ClubSwan 42 Deck Layout Toilet Hatch

Notice #03/2019

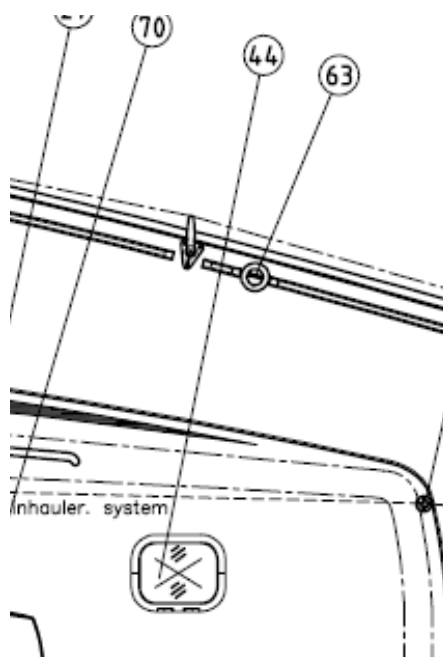
A question has been asked if it is possible to remove the Toilet Compartment Lewmar Hatch (Item 44 below)

This is a mandatory deck fitting and it is **NOT PERMITTED** for this to be removed. Additionally it is **NOT PERMITTED** to replace the glazing with an alternative material.
